January 28, 2013

Re: Joint Association Comments on the Draft White River Draft Resource Management Plan Oil and Gas Amendment and Environmental Impact Statement

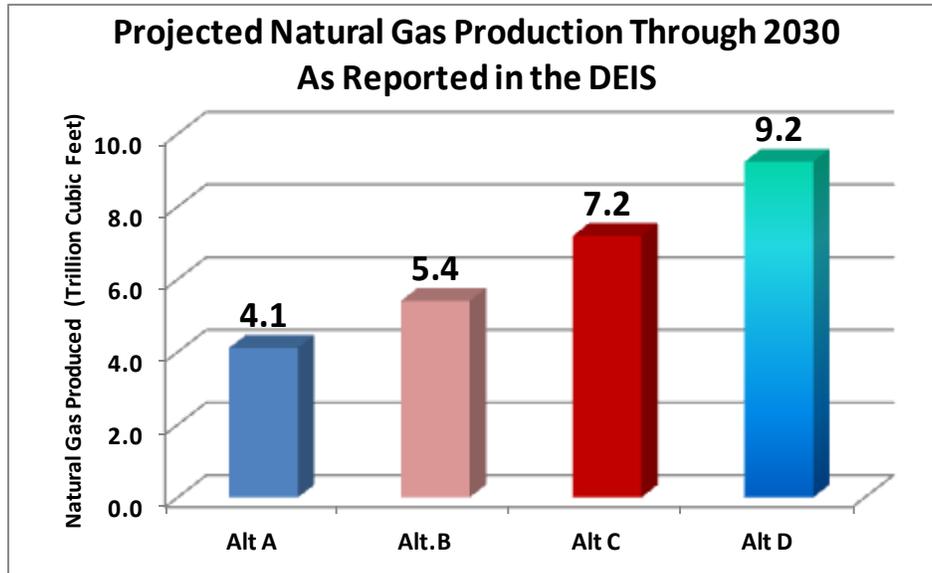
COMMENT: There are multiple omissions and inconsistencies in the revenue projections presented in the Draft RMPA/EIS. Consequently, the assessment dramatically understates the fiscal benefits associated with Alternative C and D. Using information contained in the Draft RMPA/EIS to reconstruct the projections suggests that as much as 85% of the public sector tax and royalty revenues that would result from development of the oil and gas resources in the WRFO area are not recognized or reported in the DEIS. For instance, it is estimated that upwards of \$25 billion of the development that would be authorized under Alternative D is not reported in the Draft RMPA/EIS. The understatement arises from production estimates that appear lower than those presented in the RFD, non-reporting of significant revenues, and a failure to acknowledge the value of continuing production and tax revenues beyond 2031, even as the demands associated with the temporary workforce decline.

RECOMMENDATION: The fiscal analysis is essentially silent on the subject of sales and use taxes that would be generated by industry and worker spending in the region. Even though industry has certain exemptions from sales and use tax payments, such revenues can be substantial, and the large magnitude of these revenues and their significance to local government should be acknowledged.

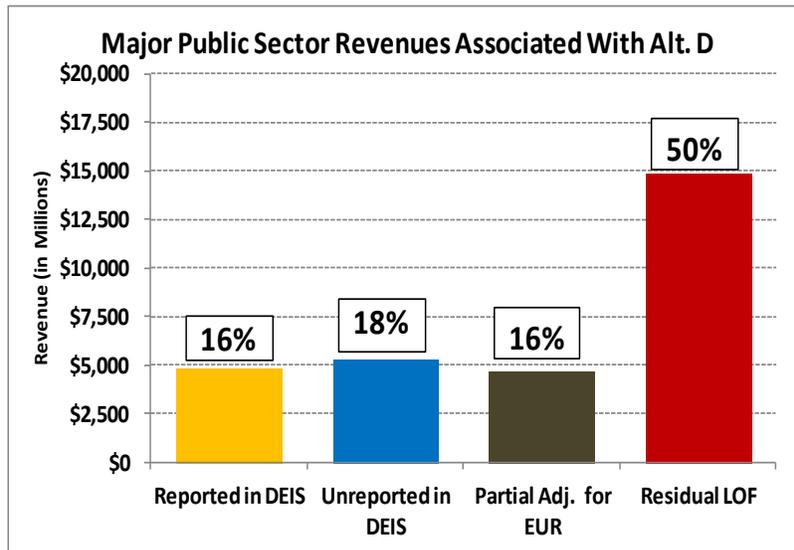
There appears to be one or more major inconsistencies between the 2007 RFD and the production and fiscal assessment presented in the SEATR and the Draft RMPA/EIS, the root of which appears to be in the computation of annual production associated with the assumed drilling program. As discussed above, summing the annual production values in Table 4-105 yields production of 9.2 Tcf during the forecast period. Yet the 2007 RFD analysis indicates projected production of 19.8 Tcf during the same period; the difference representing more than a 50% understatement/discounting of the fiscal benefits of Alternative D in the Draft RMPA/EIS – in particular the FMR and ad valorem taxes. Again, the differences are non-trivial, potentially amounting to an additional \$7 billion in FMR through 2030. To the extent that the difference represents a miscalculation based on the average annual production per well, a similar understatement would be associated with Alternatives B and C as well. Moreover, the public sector revenues generated from the additional production would help address the public expenditures needed to serve growth.

RECOMMENDATION: The production and fiscal estimates in the Draft RMPA/EIS should be reviewed and, if incorrect, the corrected figures should be presented in the Final RMPA/EIS. The revenue analysis should account for the fact that production and tax revenues from producing wells would continue beyond 2030. The 2007 RFD indicates an average estimated ultimate recovery (EUR) in excess of 1.6 Bcf per well. Applied to the total number of wells under Alternative D, that EUR yields total ultimate recovery of nearly 32 Tcf, compared to the 9.2 Tcf presented in Table 4-105. In other words, assuming the 32 Tcf is correct, the production and revenues reported in the Draft RMPA/EIS represents only a small portion of the projected total of that associated with activity that could be authorized under the oil and gas amendment. The additional revenues represent additional economic benefits associated with the BLM management actions outlined in the RMP and should be recognized. This could be done through the addition of another row in tables 4-95, 4-98, 4-102, and 4-105, as well as in a summary table in both sections 4.10 and Chapter. 2, or through the use of a figure such as that below, which illustrates the issue for Alternative D. In the case of Alternative D, Table 4-105 reports total revenue of approximately \$4.8 billion through 2030. However, over the productive life of the wells that would be authorized, the total revenues, based on the assumptions in the Draft RMPA/EIS and RFD, would be on the order of \$30-to-\$35 billion, 6 times the level reported.

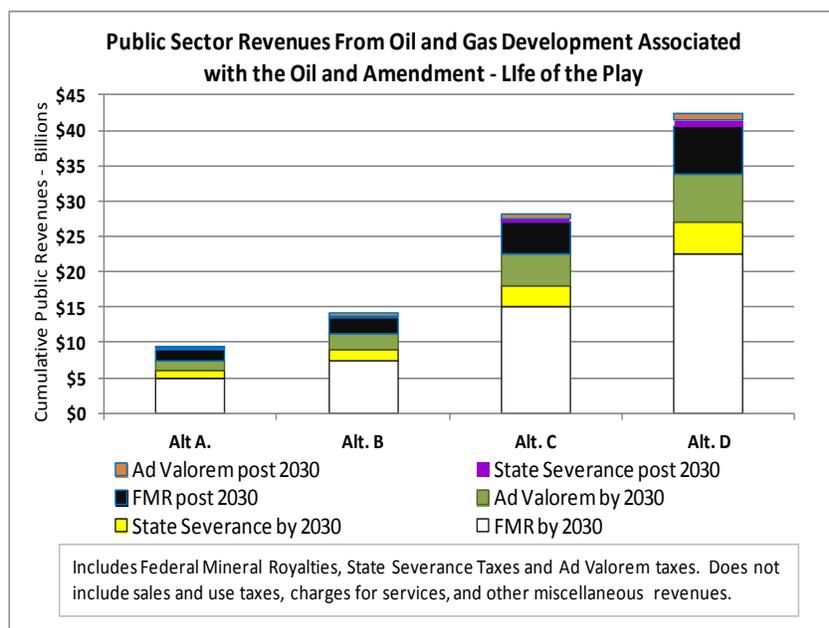
COMMENT: The potential tax lag issues described in the SEATR (see Section III, Pg. 13) and the assessment can be an issue in some instances and can apply to the need to increase staff as well as to capital facilities. However, the assessment fails to note that a common long-term benefit of energy development is that the expansion of the tax base often allows local tax rates to decline as an increased portion of the tax burden is shifted to industry, and also may allow increases in the level and quality of services provided to the public. Evidence of such shifts and enhancement exist in new/renovated hospitals, fire protection service, and community recreation facilities in many energy-resource

RECOMMENDATION: It is necessary for the Final RMPA/EIS to include a discussion of the long-term tax benefits to communities in energy development areas.
